Bradley Heights Apartments

A 236-Unit Apartment Development Puyallup, Washington

SITE PLAN 236 UNITS
1" = 40'

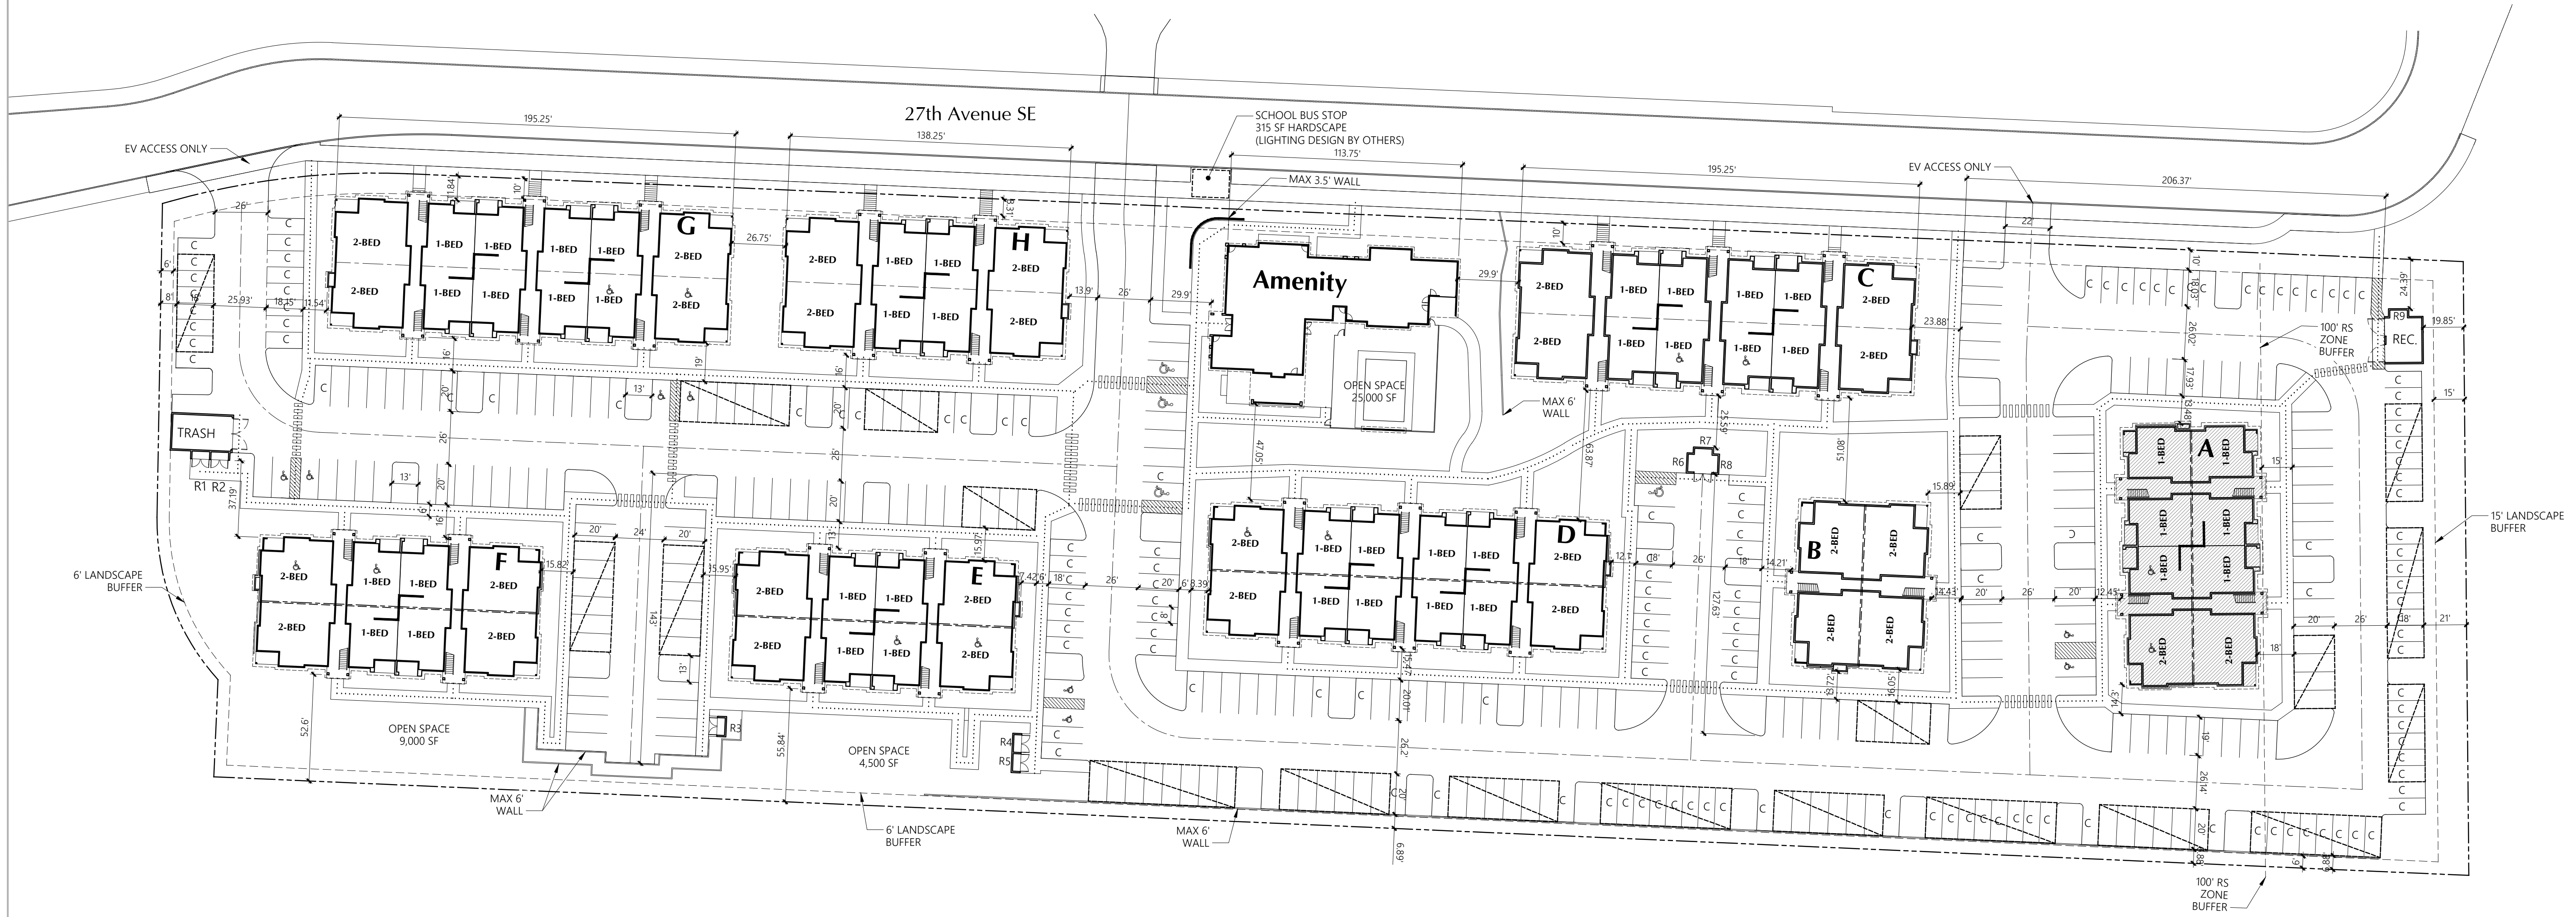
Revise to match 2018 Prescriptive Energy Code Compliance report. Page A

Report selected 1.7 credit; plans show 1.1 credit

Provide egress plan with all dimensions with travel distance for all floors.
Page A2

BUILDING A BASEMENT LEVEL PLAN
1/8" = 1'-0" 3/4 SPLIT LEVEL, 28-UNIT BUILDING

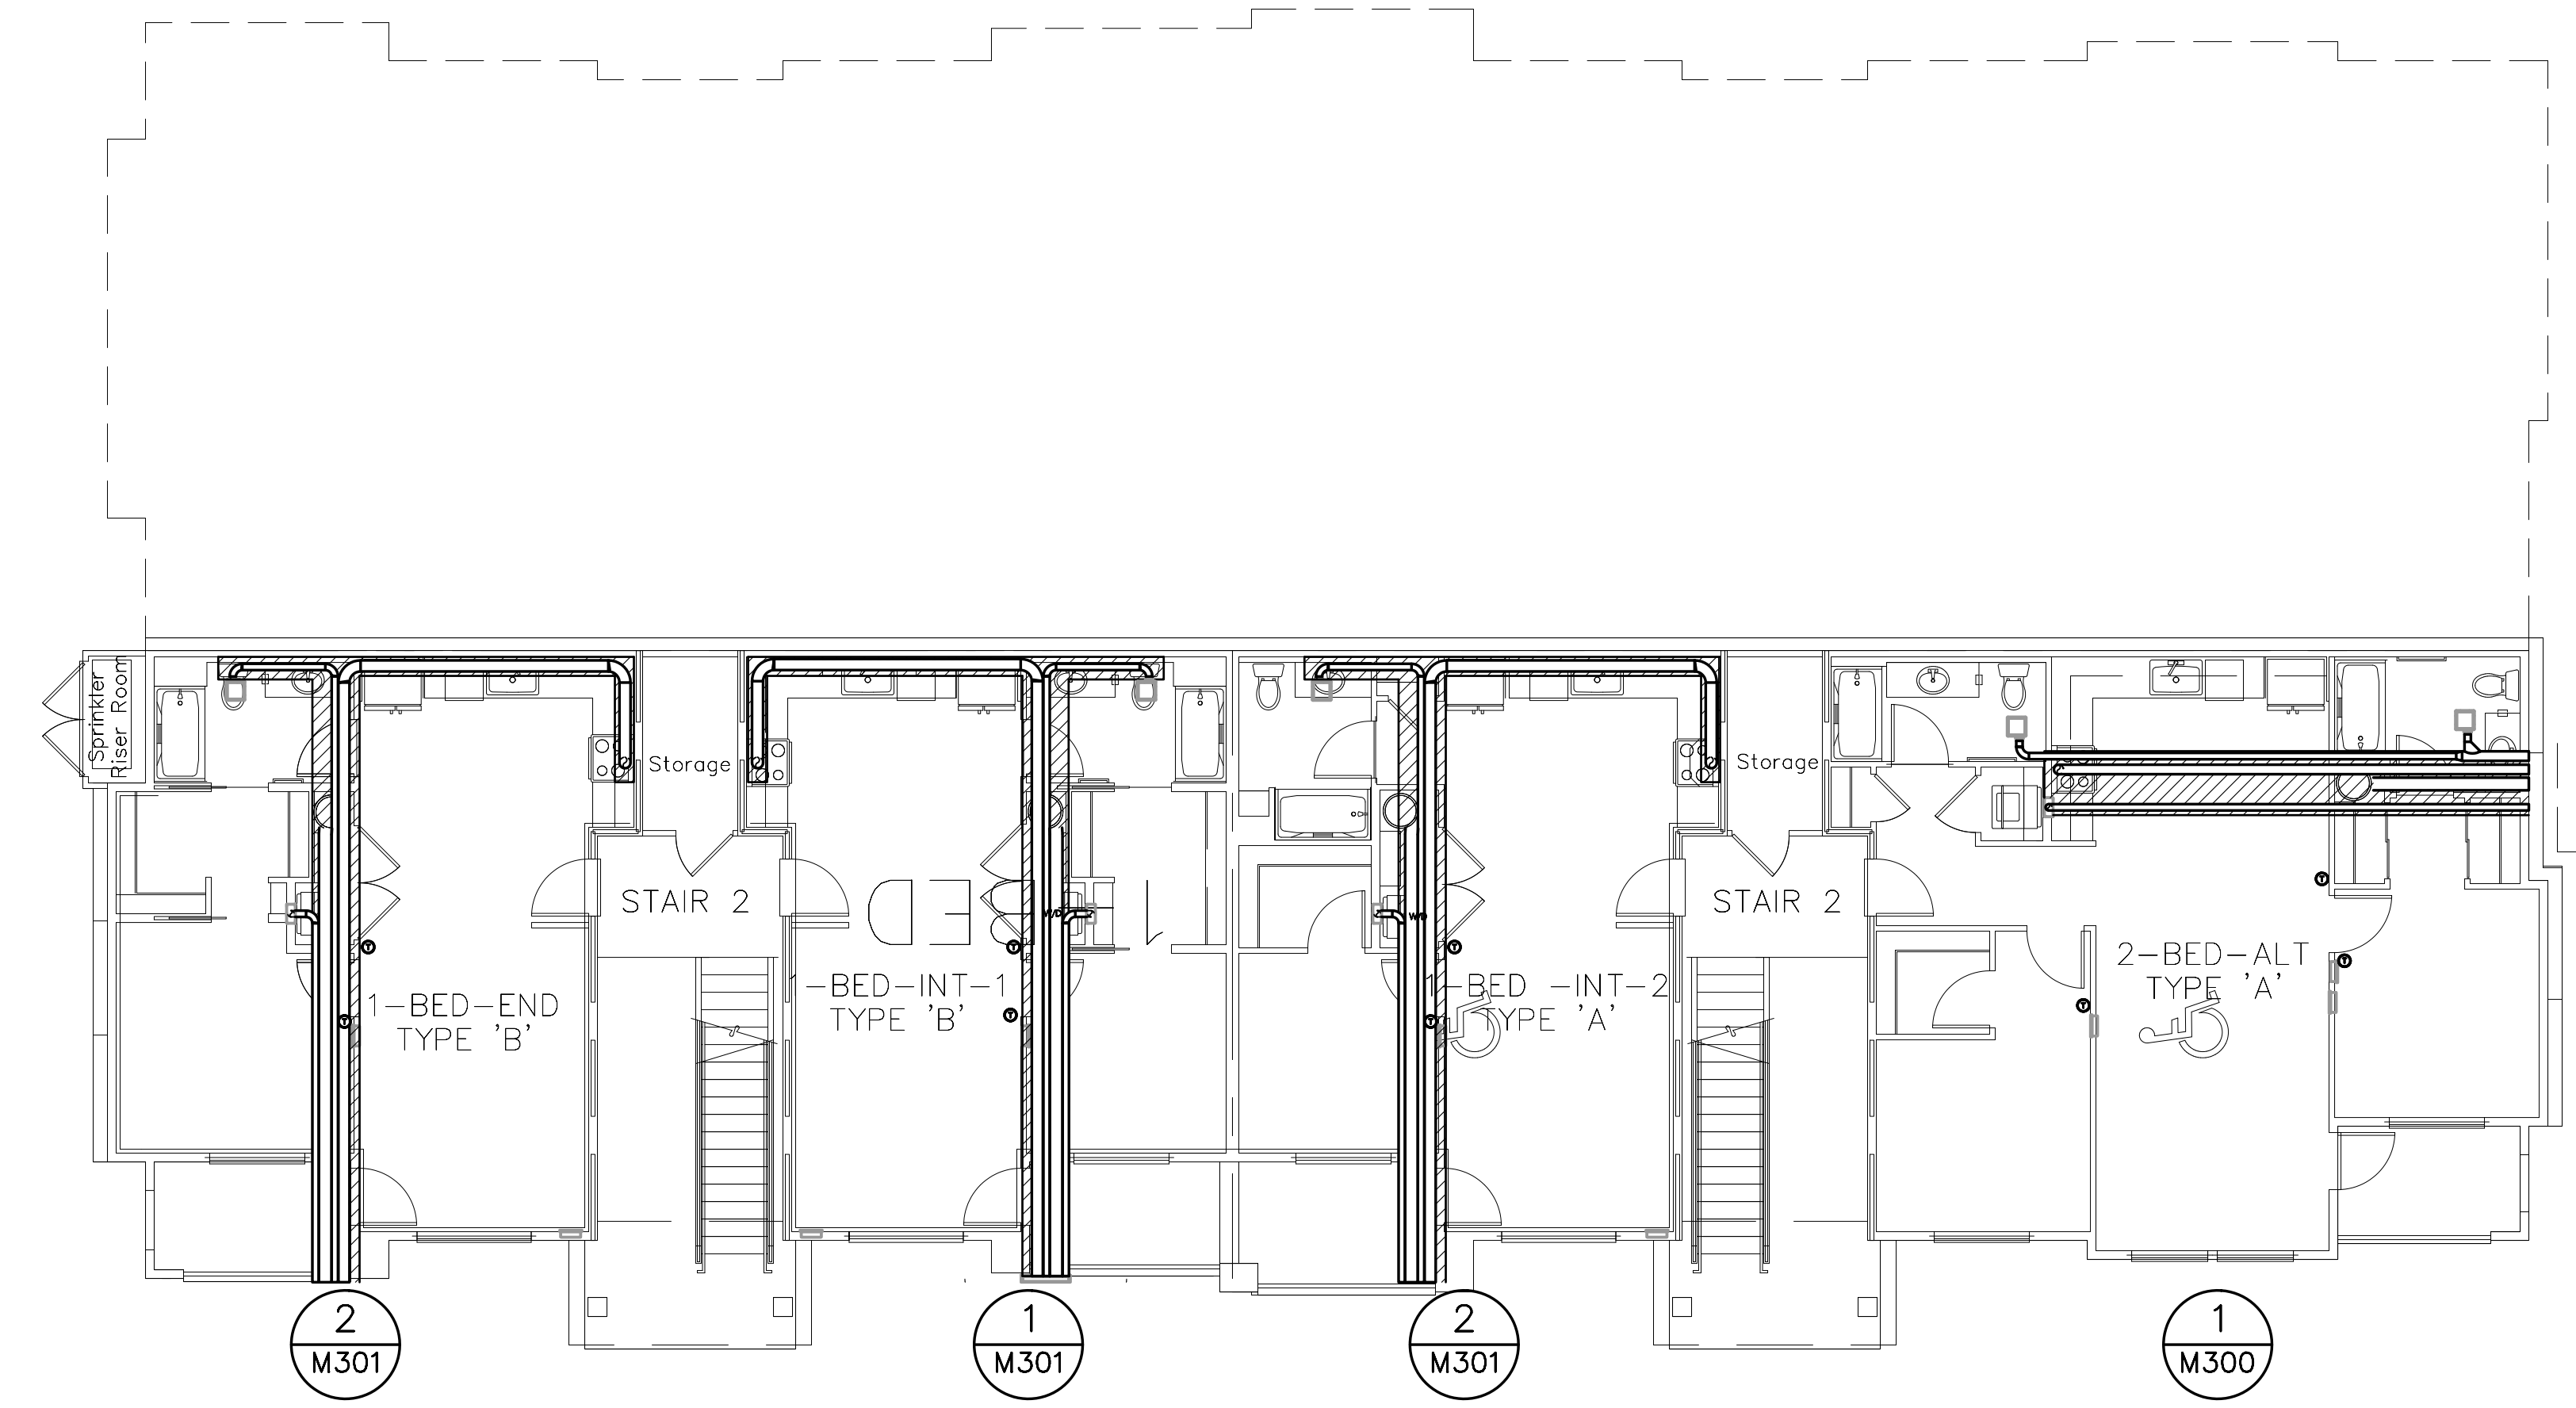
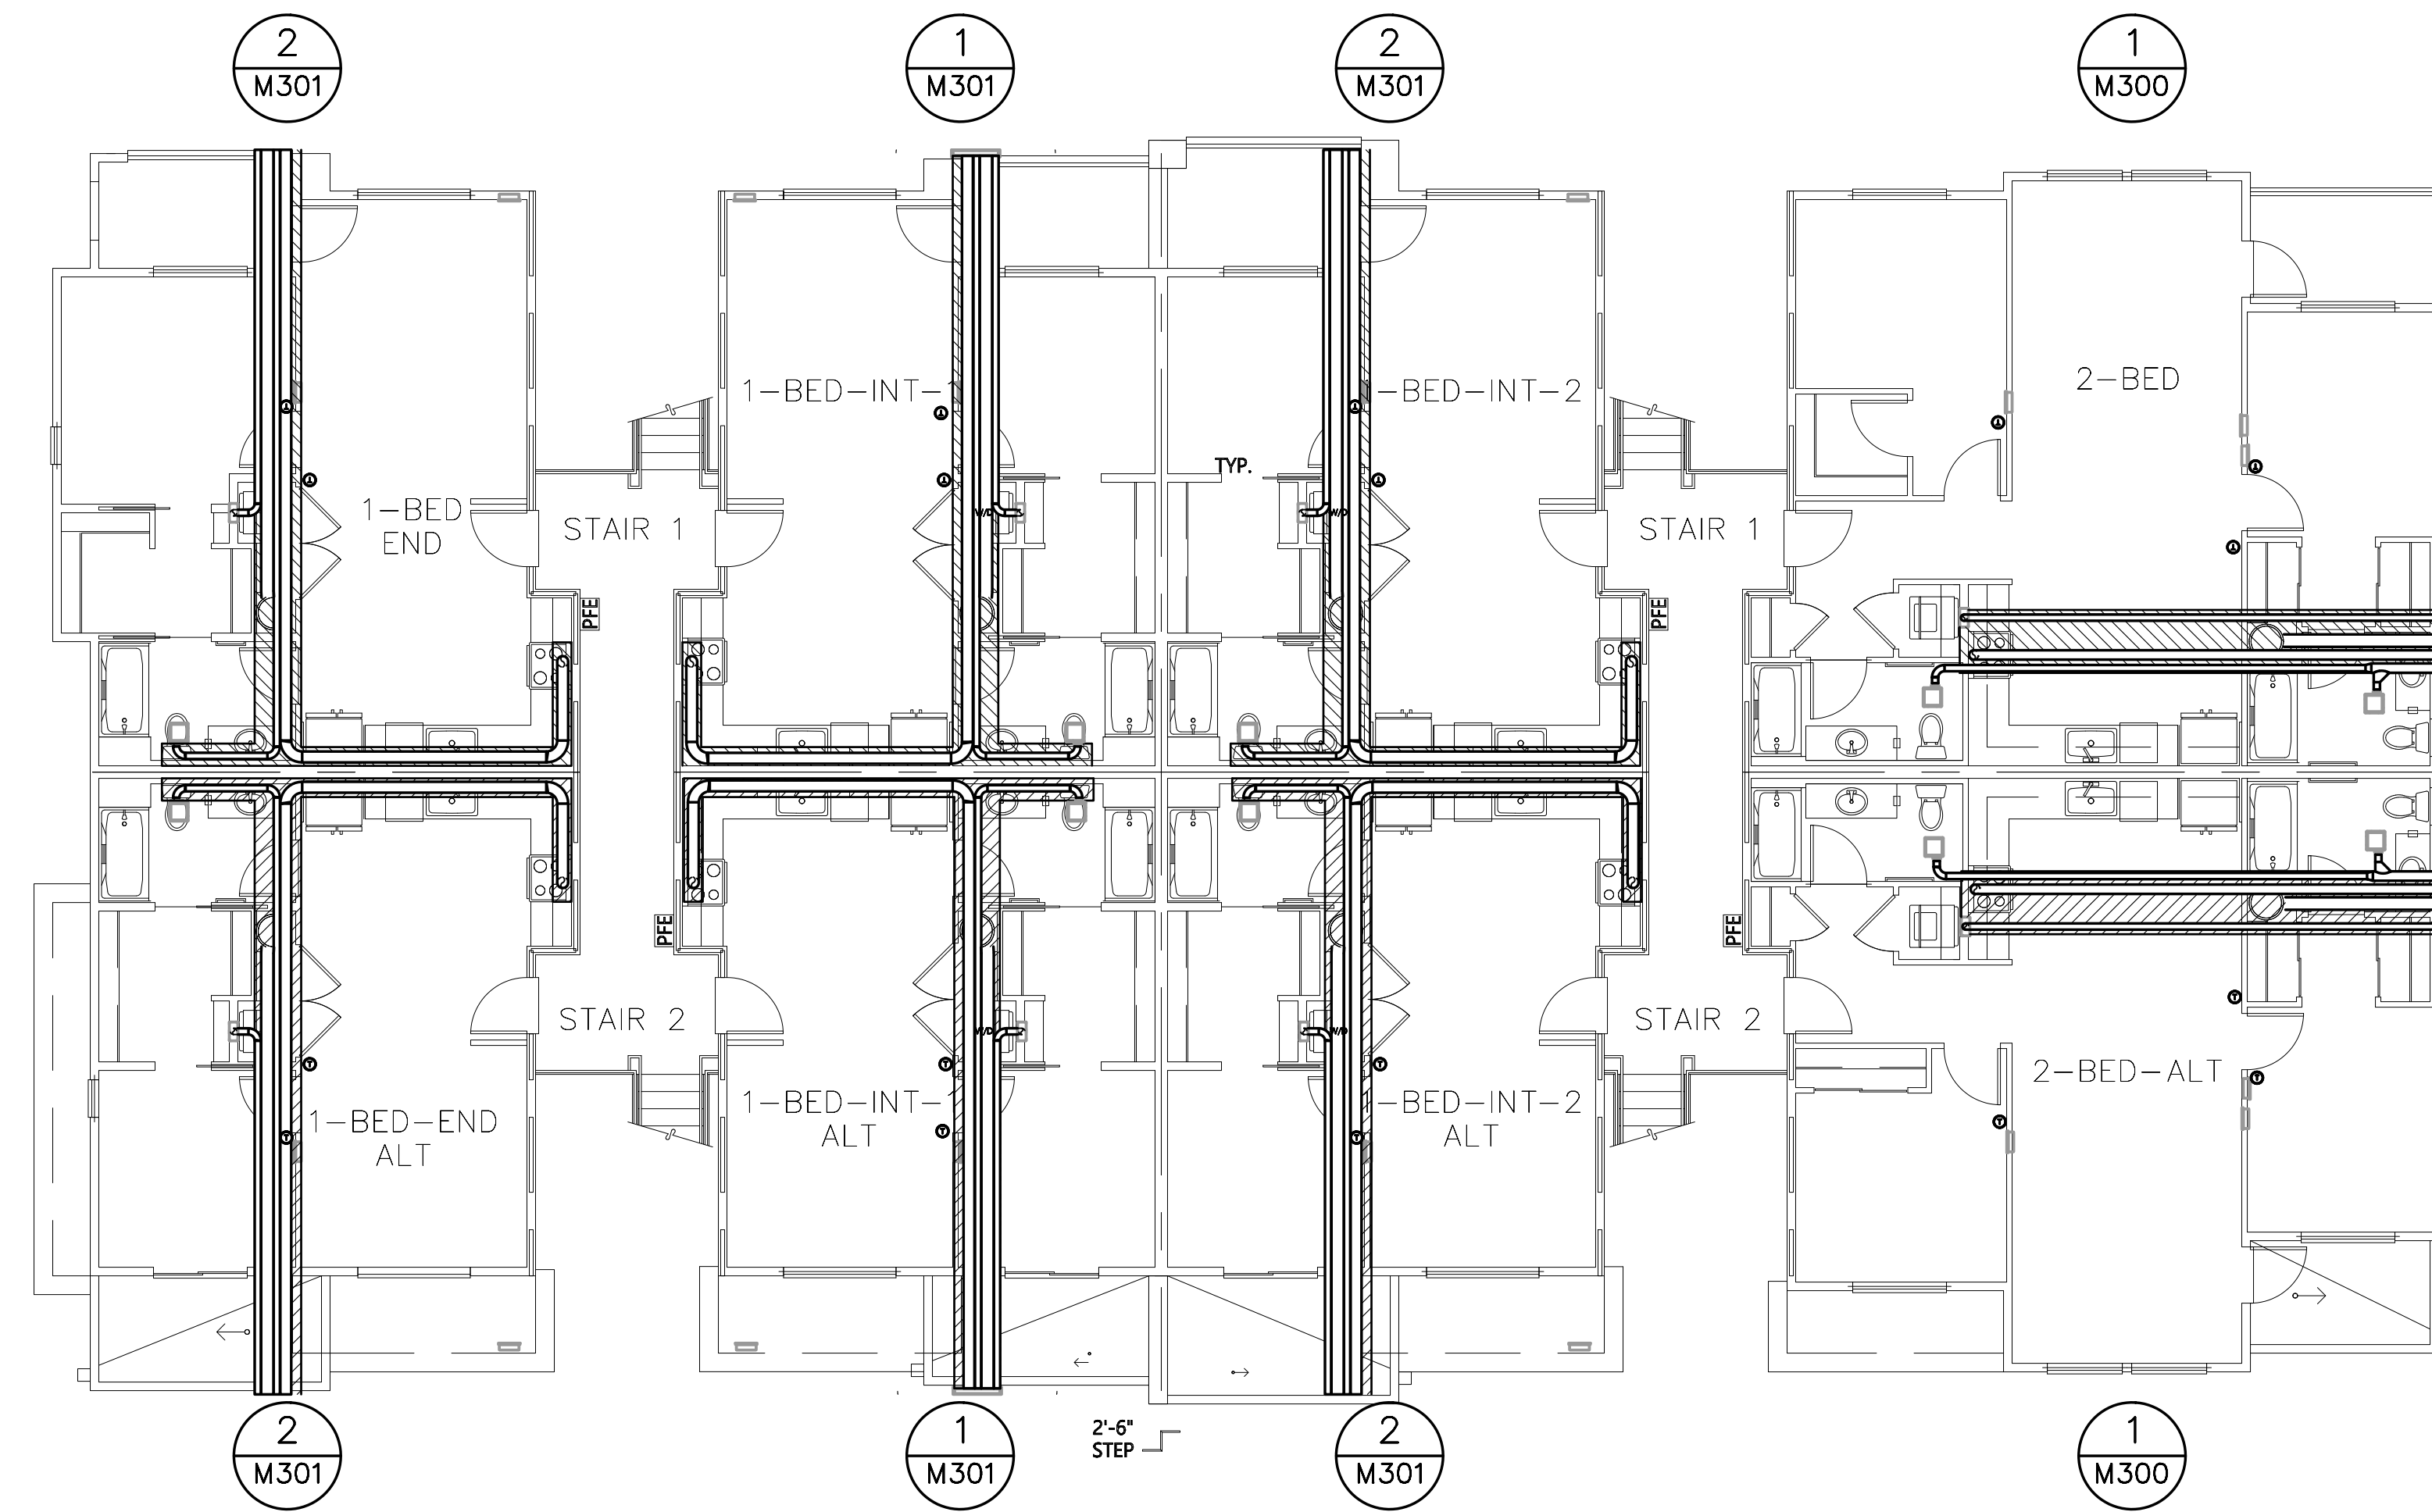
Provide lengths to all duct work for all floors to identify maximum duct length for all areas.
Page M3.0
